C 880668 1 of 1

△ OBSOLETE		↑	LATÃO / BRASS	↑	- 2
		↑	PRÉ-ESTANHADO/PRE-TIN	BRONZE FOSF/PHOS BRONZE	880668 1
			FINISH	MATERIAL	PART NUMBER
CUSTOMER DWG for REFERENCE ONLY		THIS DRAWING IS UNPUBLISHED RELEASED FOR PUBLICATION			
		C COPYRIGHT 19 BY AMP DO BRASIL LTDA S.P. ALL INTERNATIONAL RIGHTS RESERVED AMP PRODUCTS MAYBE COVERED BY US AND FOREIGN PATENTS AND/OR PATENTS PENDING			
		TOLERANCES UNLESS OTHERWISE STATED		SCALE 10:1	
		DEC ±0,3			
		ANGLES ±2°			
		DR M.C. LAPRESA 19 MAY 93		AMP do BRASIL LTDA. São Paulo, Brasil	
		CHK <i>Fabrizio</i>		DESCRIPTION	
		A1 REVISED PER ECO-89-026444		FFC SPLICE	
		A REVISADO		A1	
		0 ERA P93-29059		SHEET 1 OF 1	
ISS REVISION RECORD		ECN	DR	DATE	APP
				28.01.93

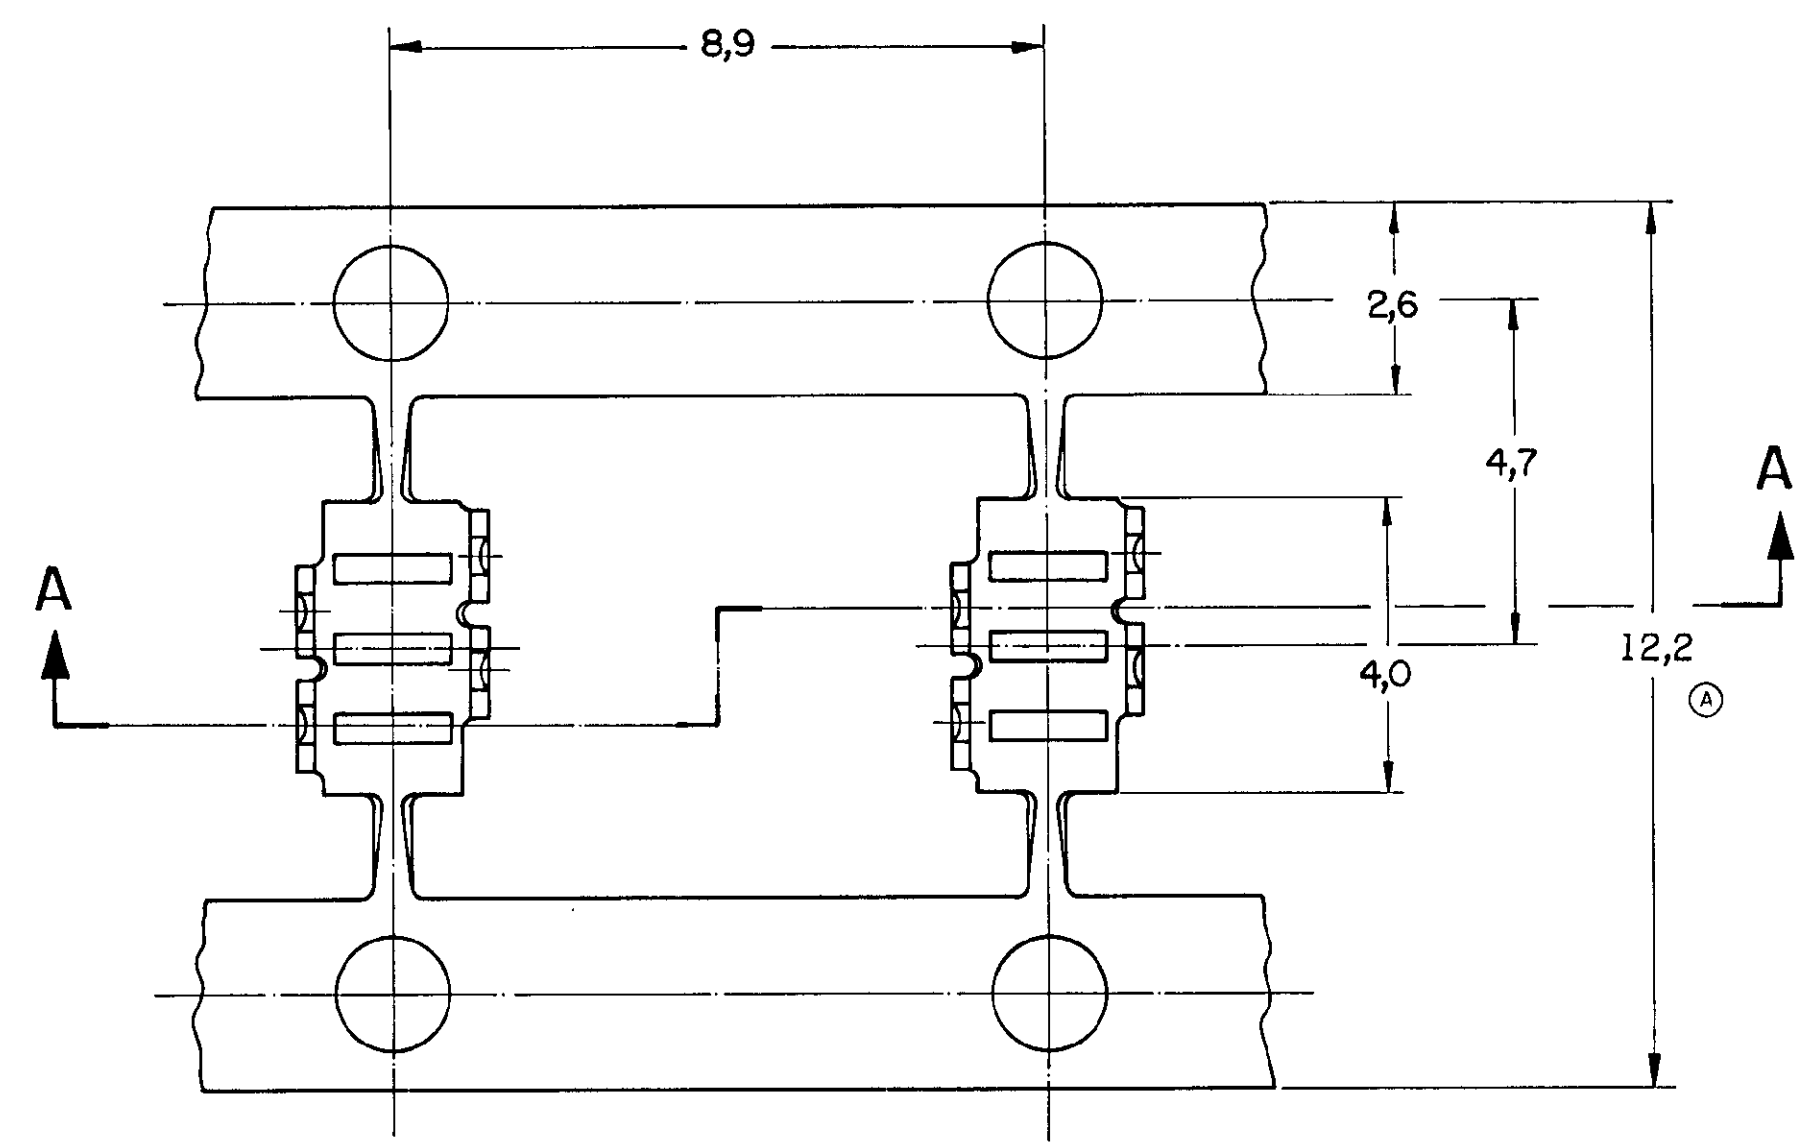
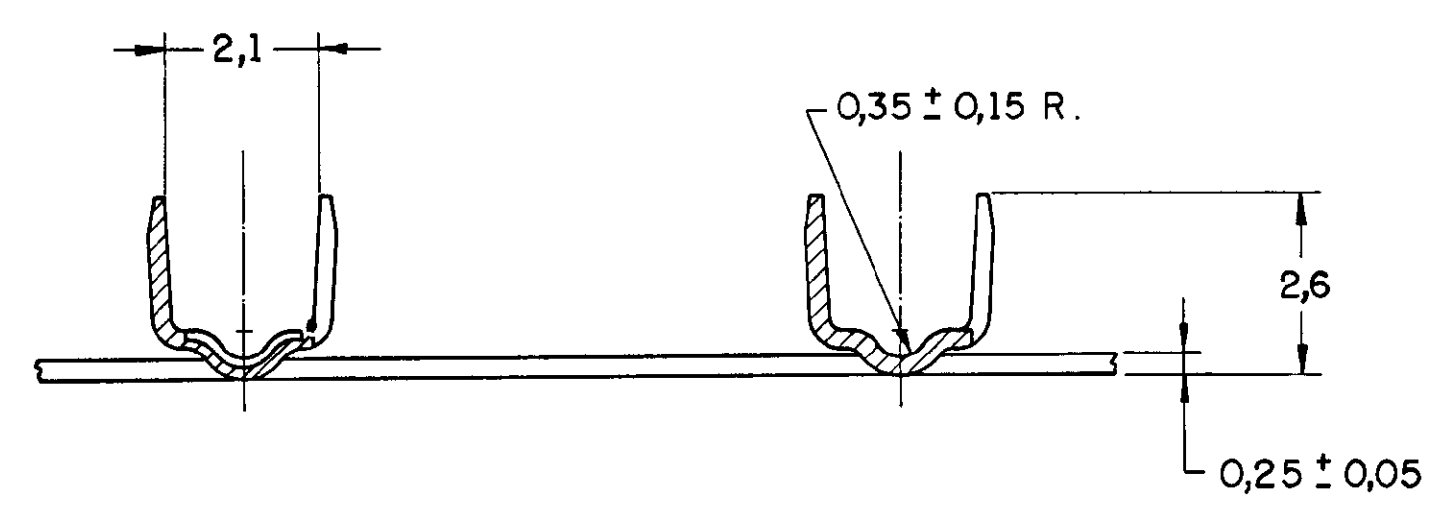
△ OBSOLETE PARTS: OBSOLETE CIS STREAMLINING PER D.RENAUD/D.SINISI
